System Pillar / EULYNX

Baseline Set 4 Release 2

Version: 2.5
Date: 15-12-2025

Error corrections

[EUP-516] [Req. Spec. P: Incorrect IO Flow on SD 2.1.2.4.9 \(Eu.P.5804\) and 2.1.2.4.10 \(Eu.P.5374\)](#) Created: 10.08.2023 Updated: 10.08.2023

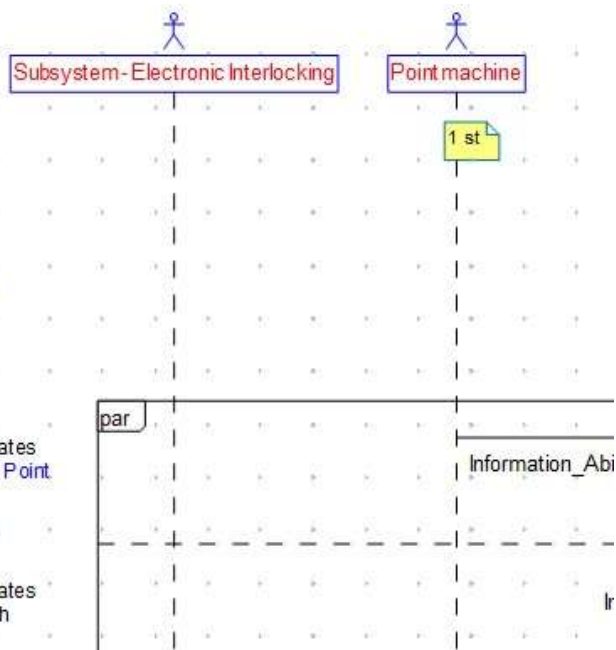
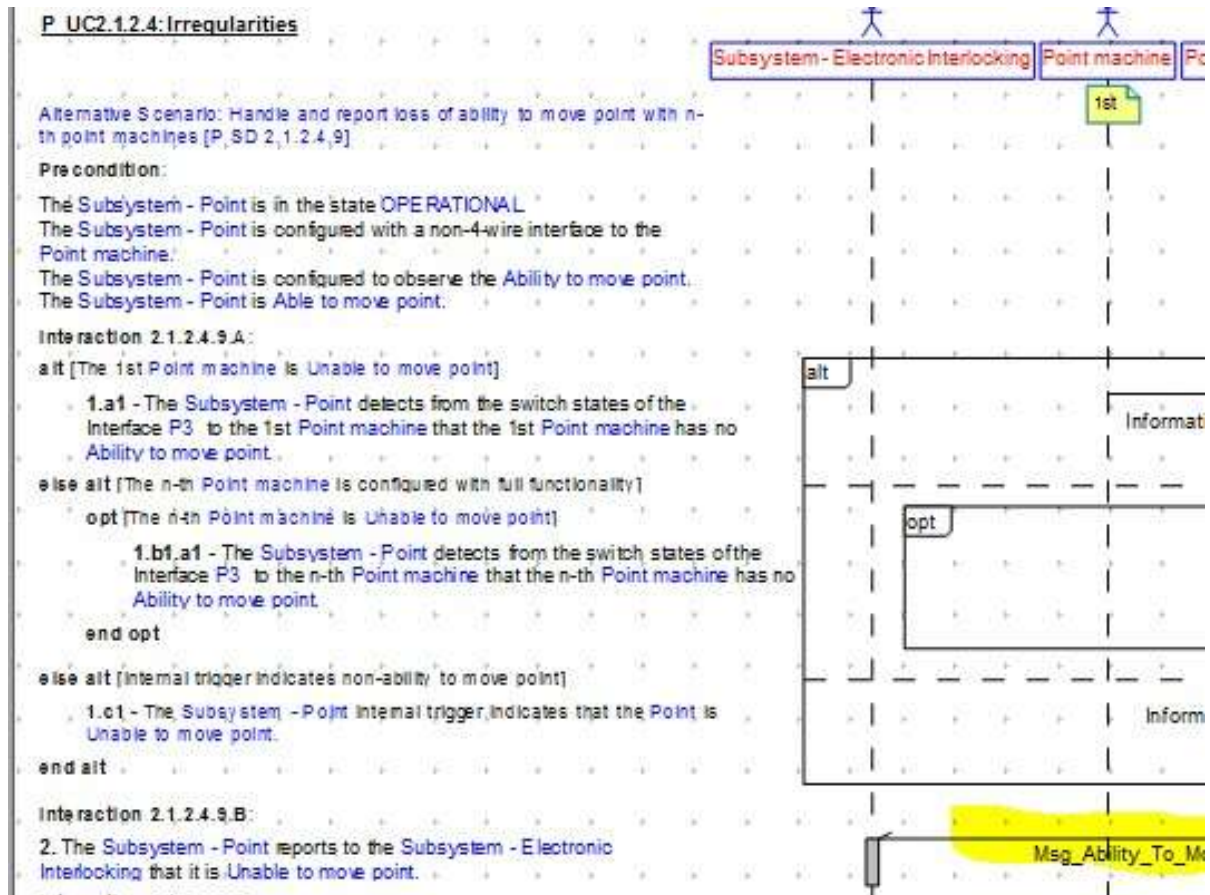
On SD 2.1.2.4.9 (Eu.P.5804) and 2.1.2.4.10 (Eu.P.5374) in on Step 2 a incorrect IO Flow is used (Msg_Point_Position).

Msg_Ability_To_Move_Point should be used.

image-2023-08-15-13-44-53-576.png

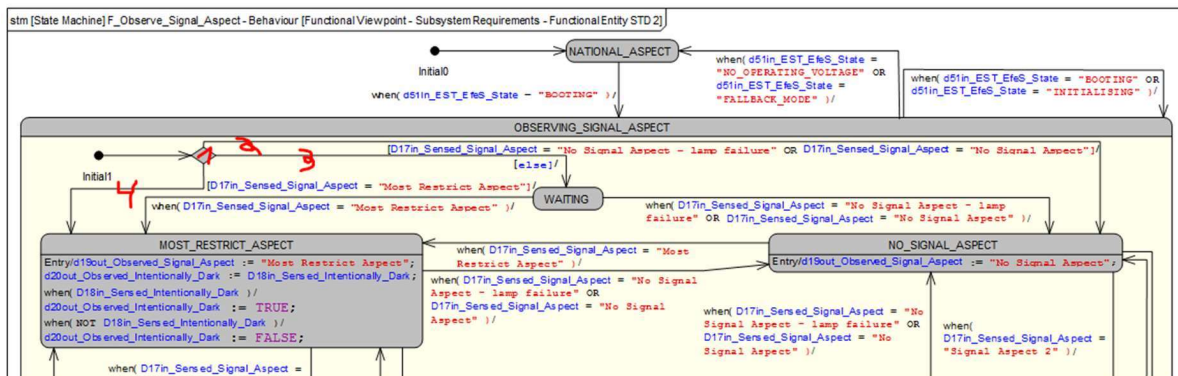
When the LS will be set from OPERATIONAL (while indicating "most restrict Aspect" back to BOOTING and then back to OPERATIONAL the controller is not able to report the newly set Aspect to the interlocking.

This is caused due to a deadlock in the observing block as it reacts just on the change trigger of D17 and can therefore not leave the state WAITING.

The STM for observe Signal Aspect shall be extended with transitions made of purely guard conditions (reacting on current state and not change trigger) as in attached pic shown. The four marked transitions/elements should be added to correct the described behaviour above.

Point STMs which were basis for BL4R2/3 simulation

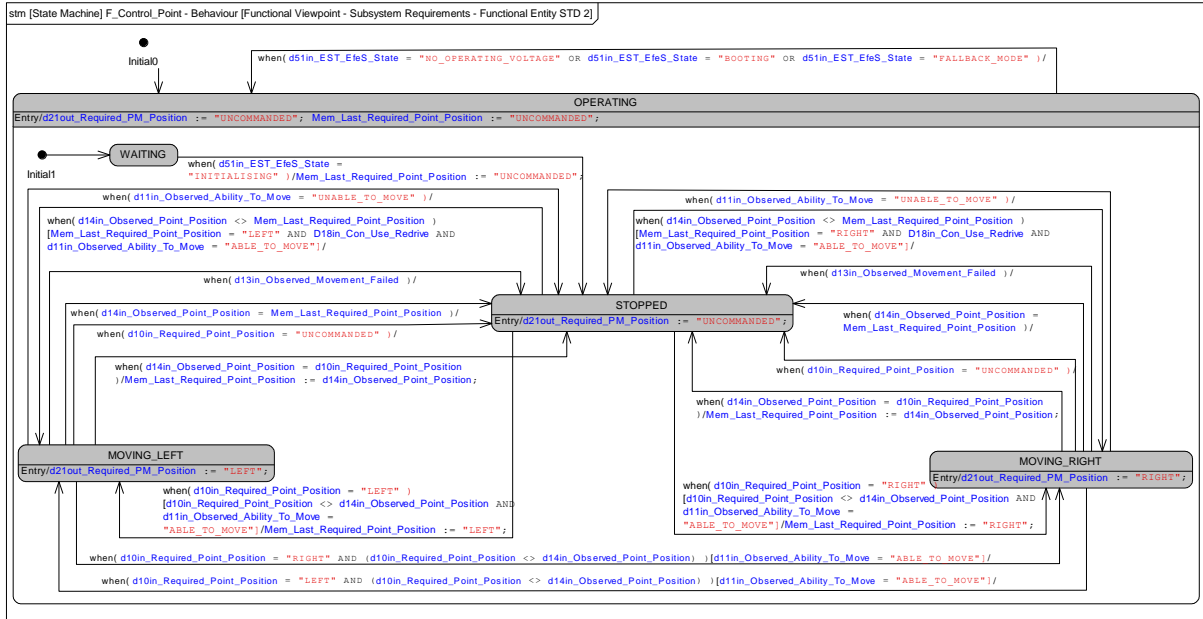
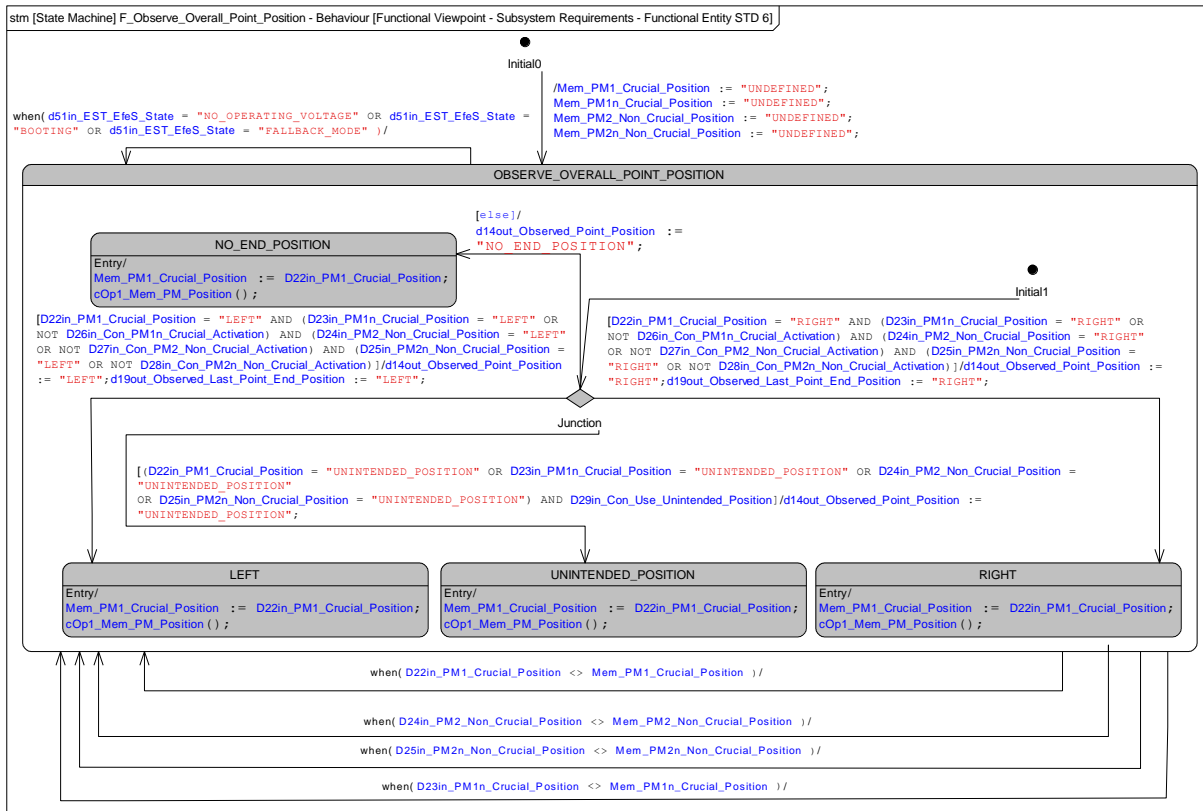
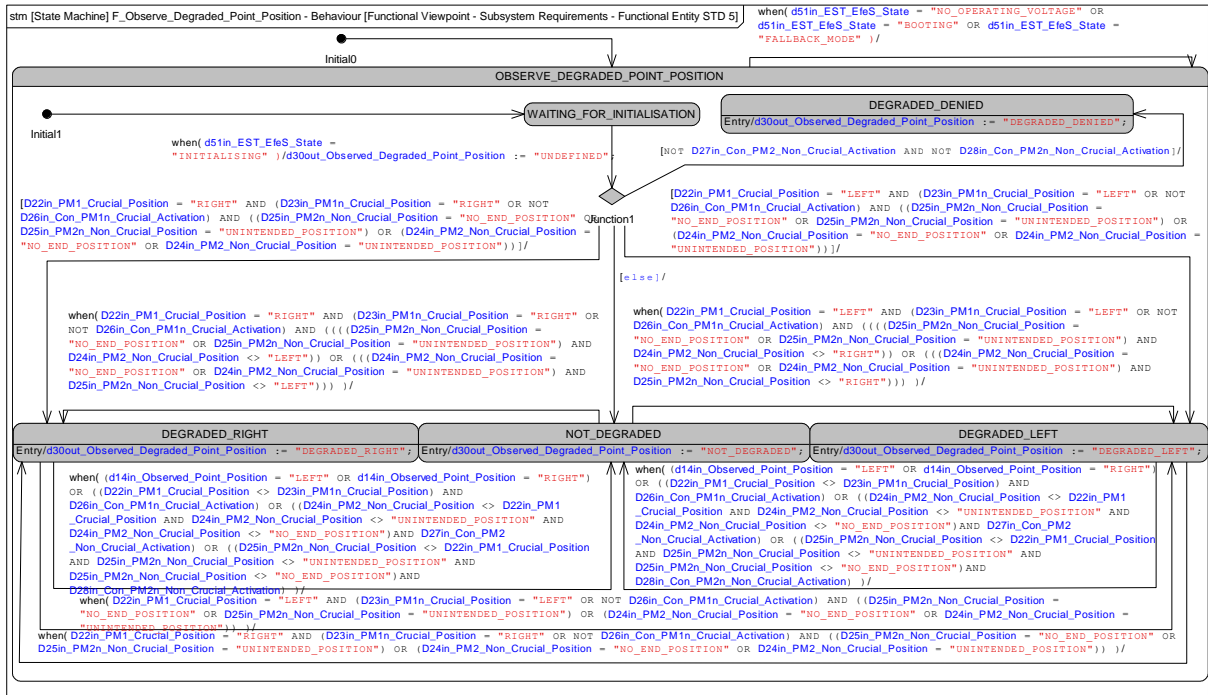
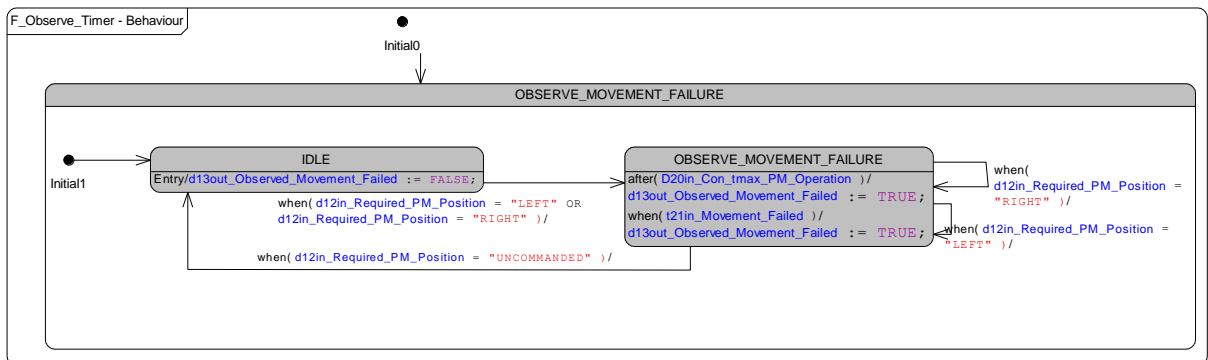
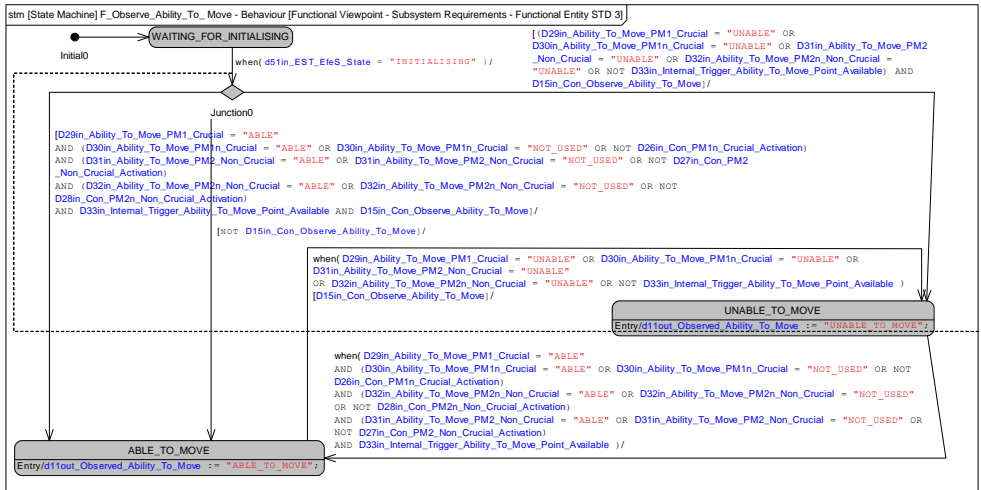
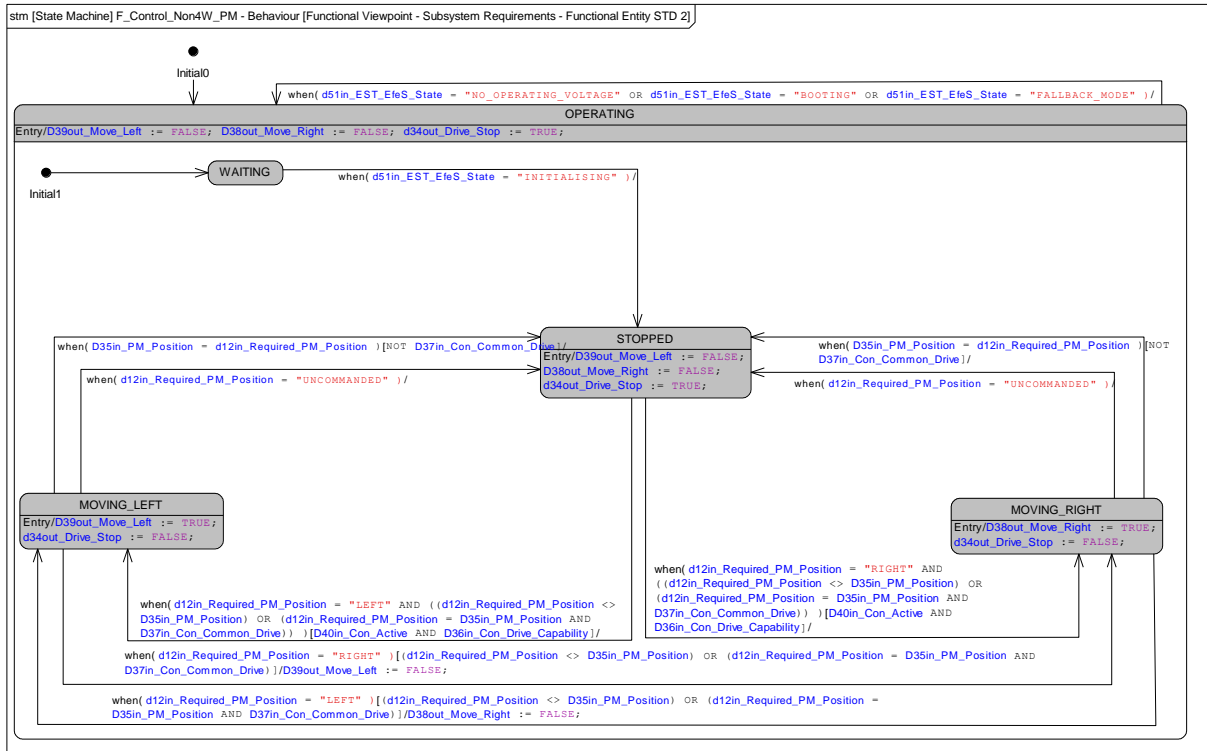
The correct transition must be `d27in_4W_PM_Position = "LEFT_REACHED" / d27in_4W_PM_Position = "RIGHT_REACHED"`.

The correct transitions are shown in the attached figure.

The latest version of the SubS Point simulator is correct, as it was based on a copied PTC model. See attached .pdf.

SPT2TACS-8740 - Correct missing Operation_State when leaving Data_Update

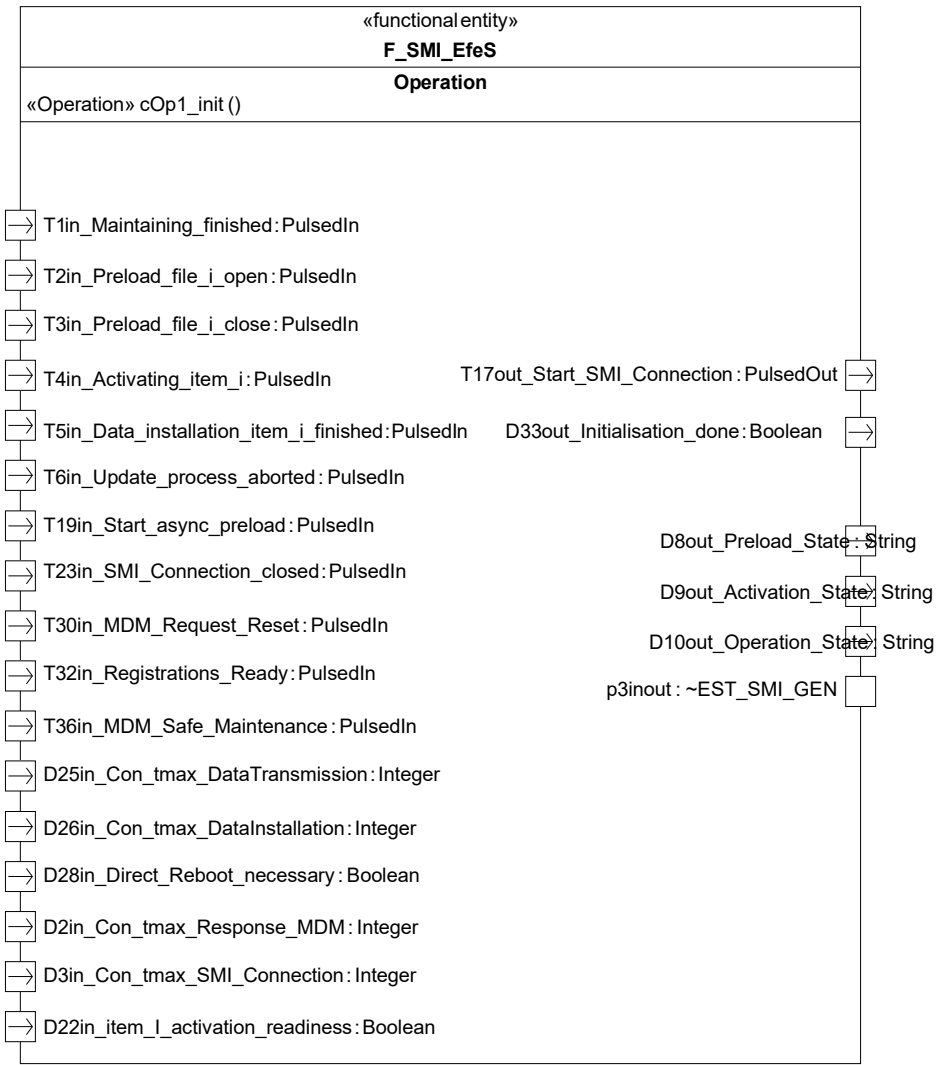
Proposed Solution: Add D10out_Operation_State = "NotMaintenance" in 3 transitions going out of the state DATA_UPDATE.

In the transition from MDM_INTERACTION_FOR_ITEM_I to ACTIVATING, delete the condition d52in_EST_EfeS_init_SubState = "WAITING_FOR_DATA_UPDATE" and replace it with D10out_Operation_State = "Maintenance". The port d52in is no longer needed.
